BVH ARCHITECTURE

ADDENDUM

PROJECT:	NSC HVAC Replacement and Window Restoration	PROJECT NO.:	BVH: L14077 OCC: 201405
TO:	Prospective Bidders	DATE:	05/16/2018
FROM:	BVH Architecture	ADDENDUM NO.:	5

MD3.2
P1

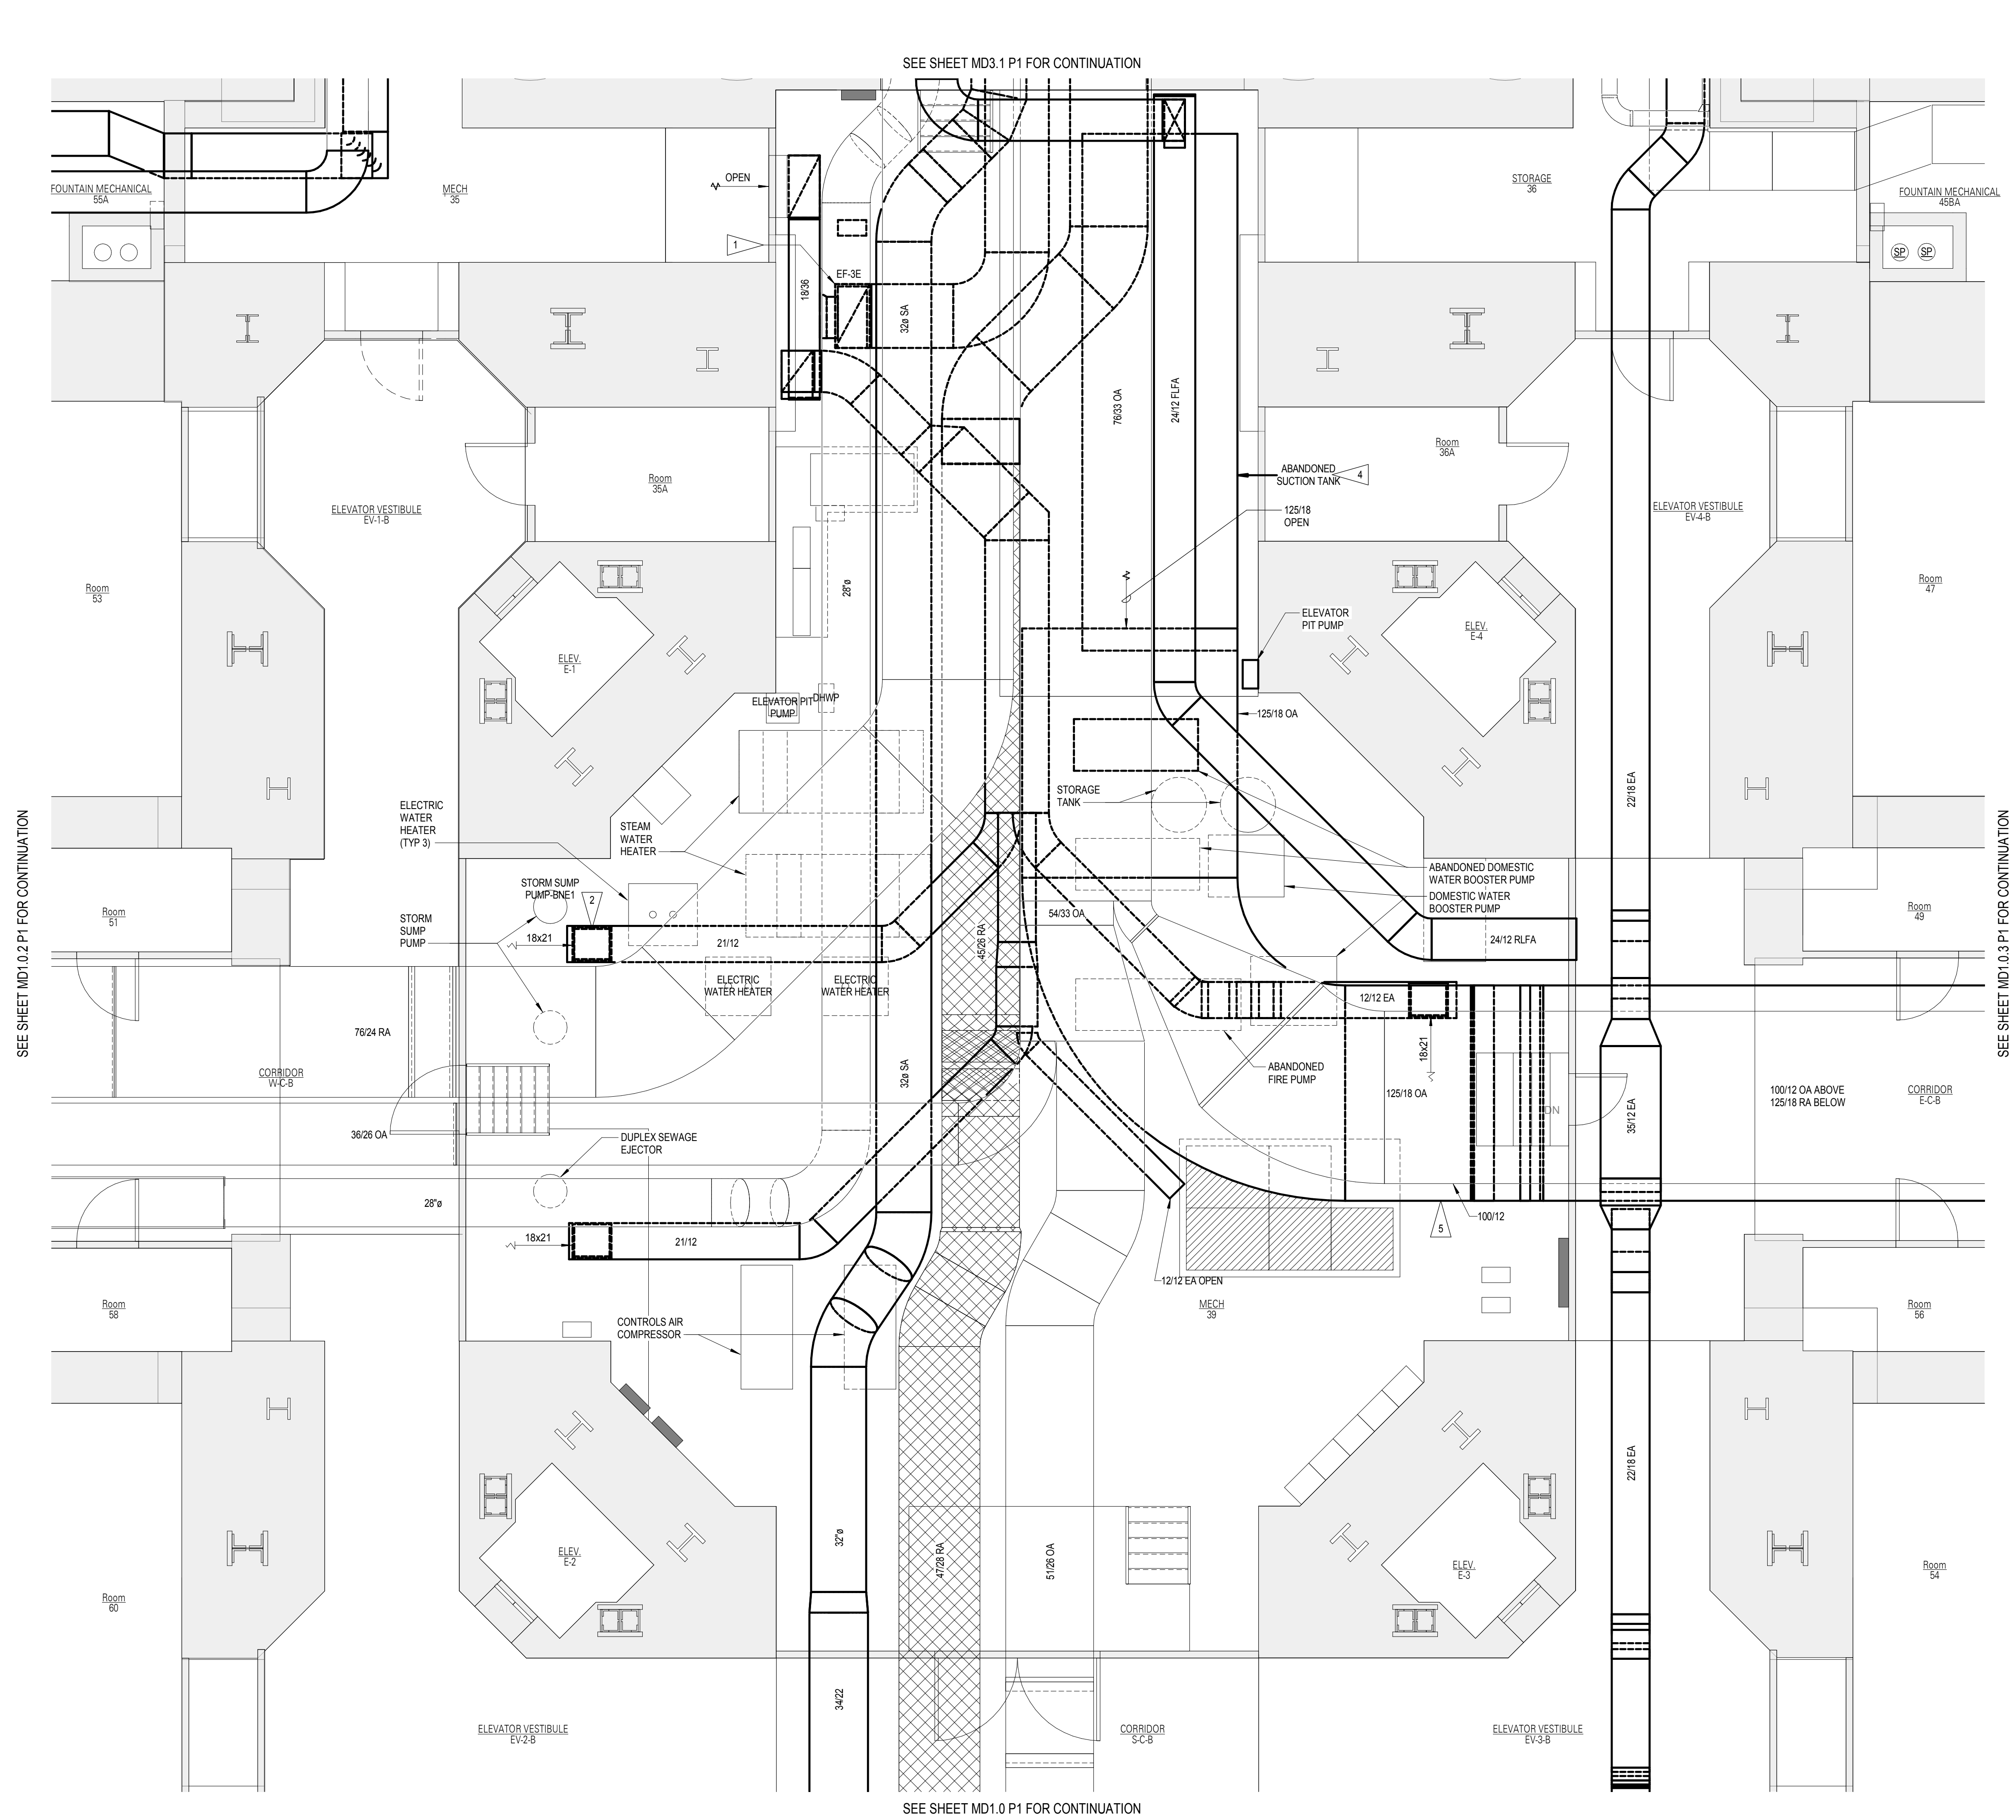
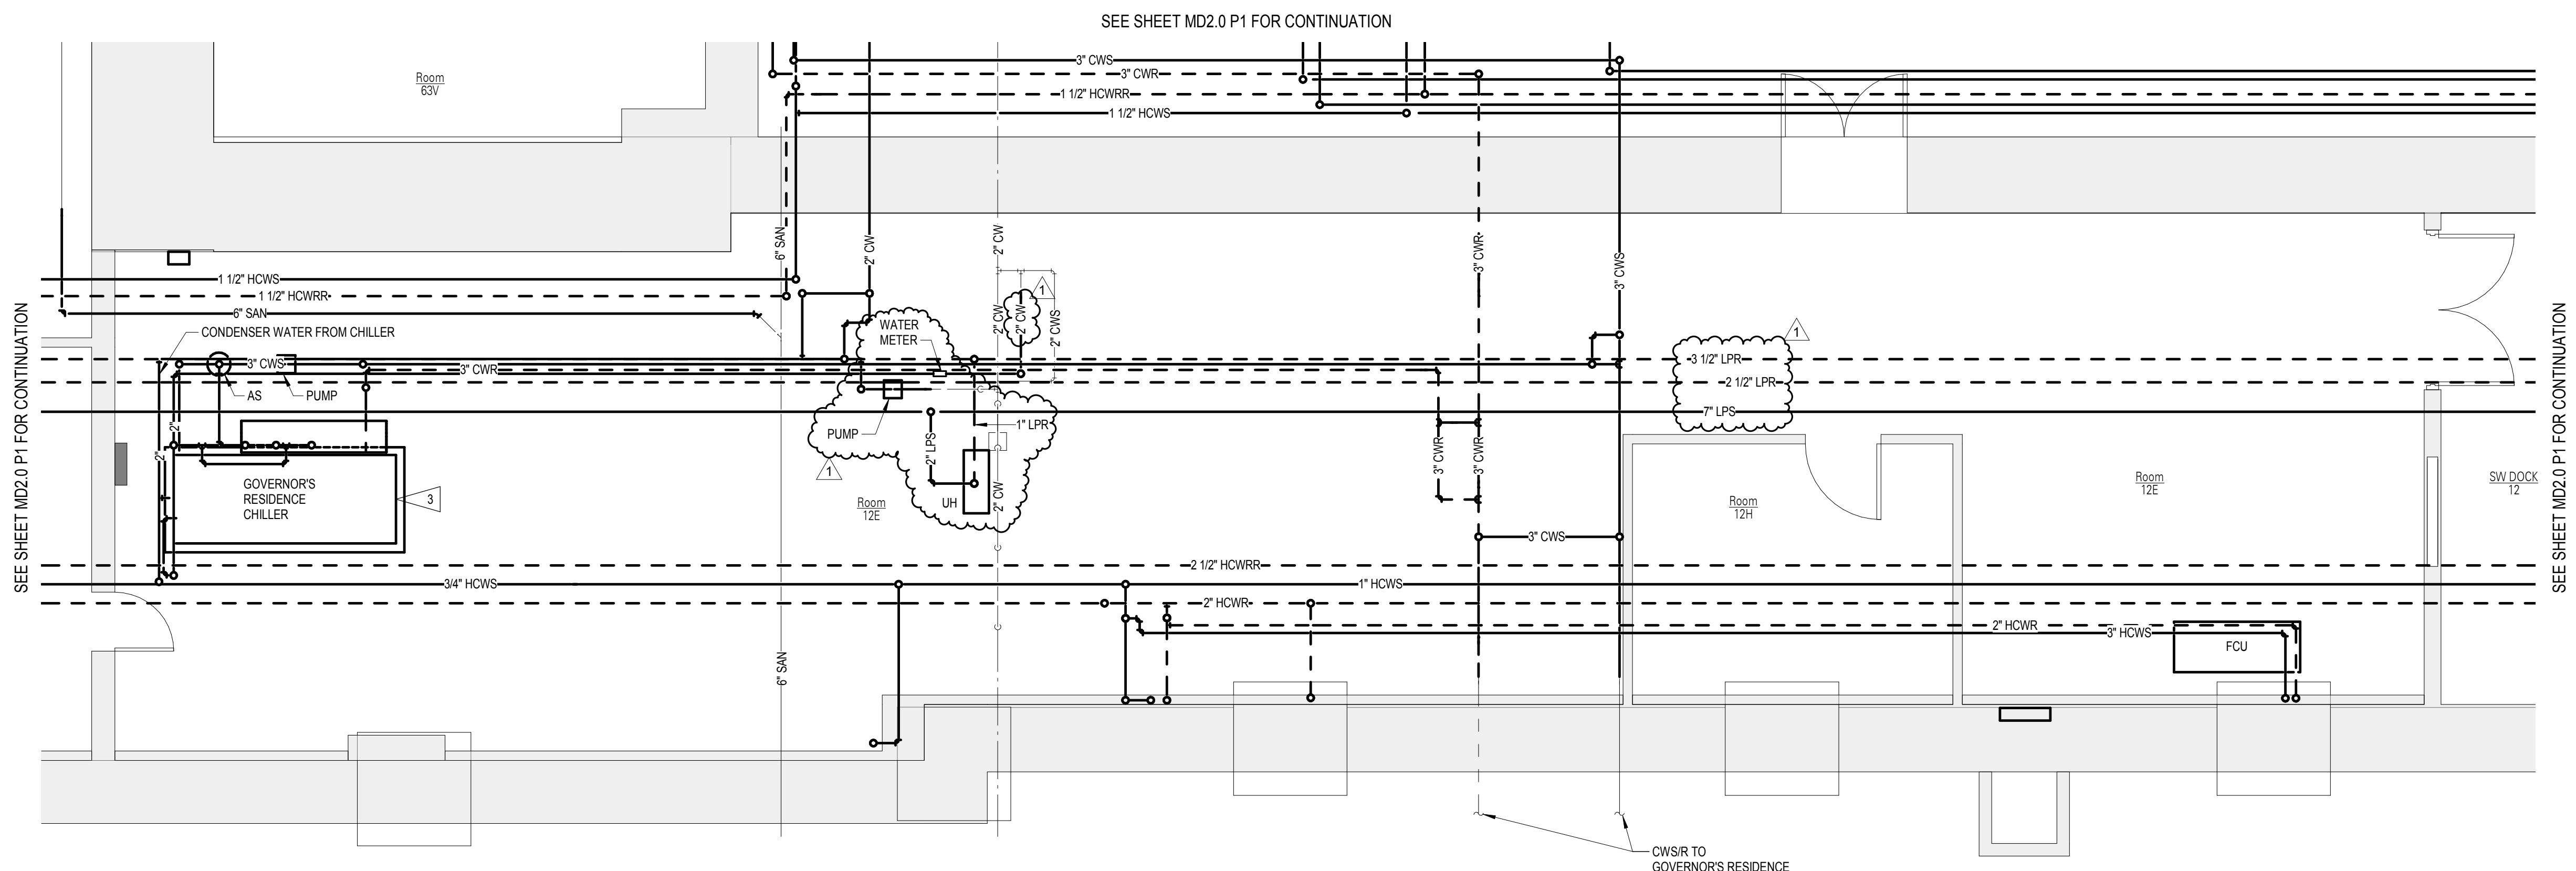
5MD8. SHEET MD3.2 P1 – ENLARGED MECHANICAL PLANS DEMO

1. Refer to clouded areas for revisions on attached reissued sheet.

NORTH
1
M1.0.3
P1

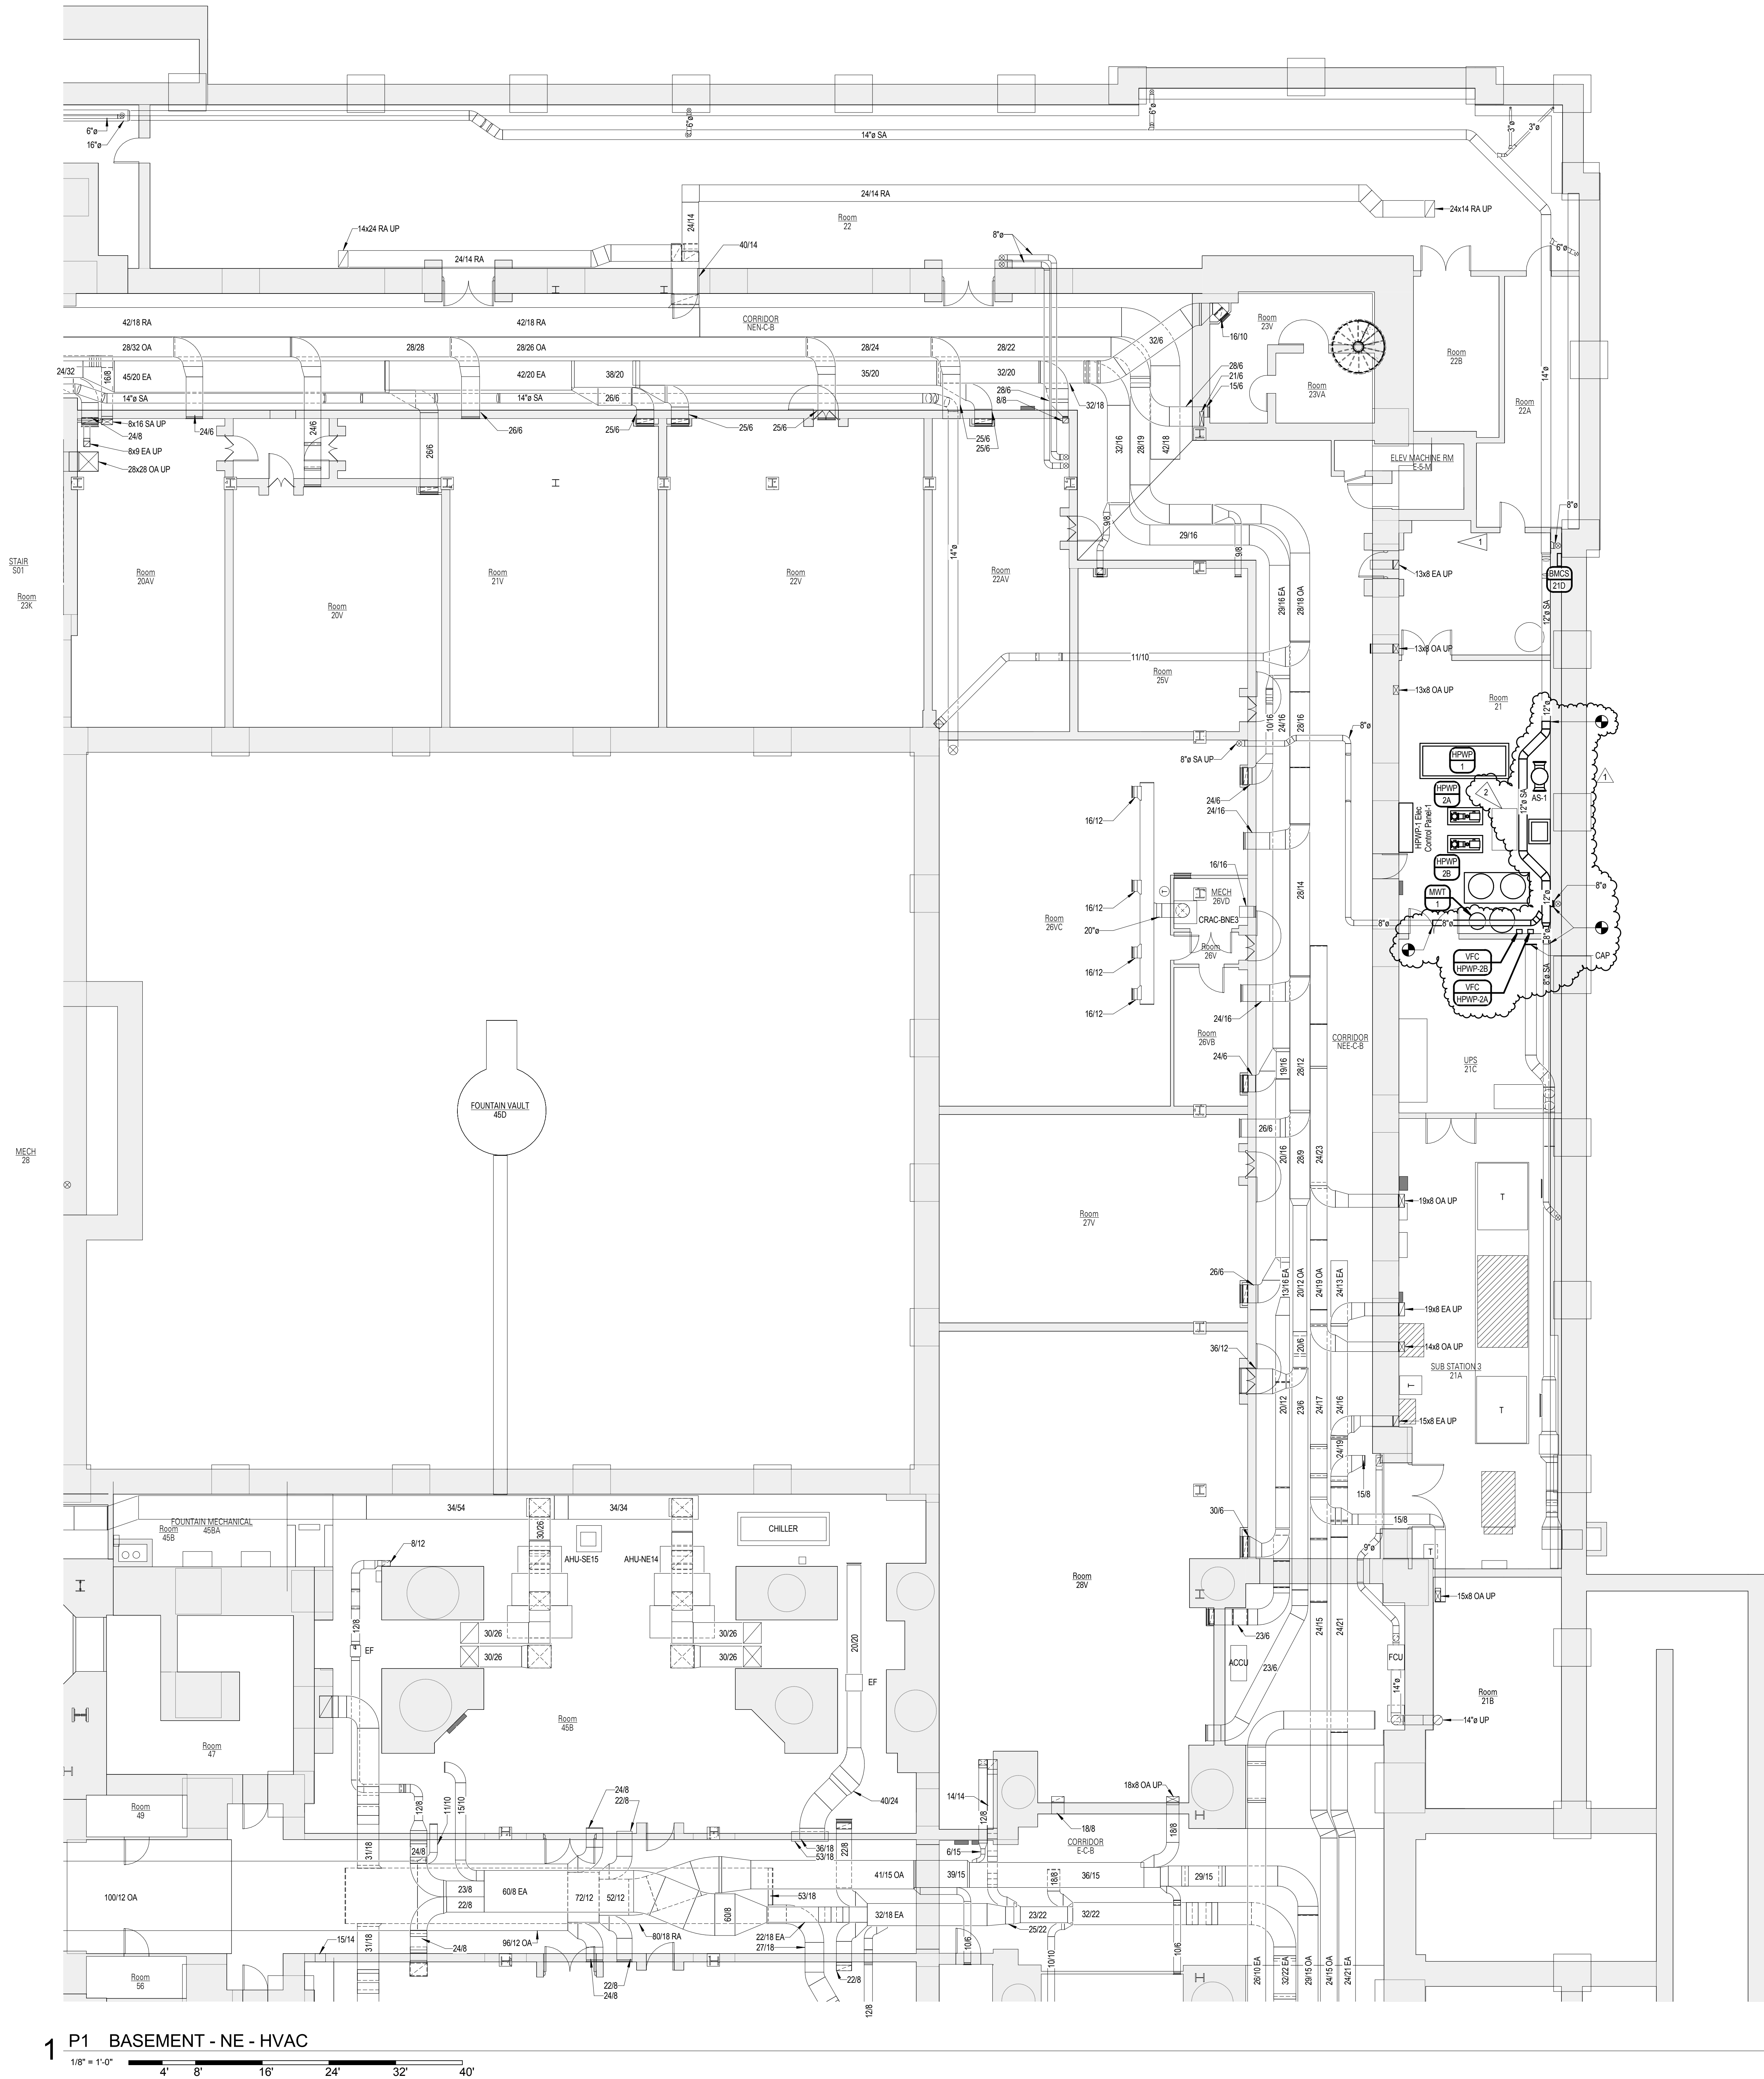
5MD12. SHEET M1.0.3 P1 – BASEMENT FLOOR PLAN – NE – HVAC

1. Refer to clouded areas for revisions on attached reissued sheet.
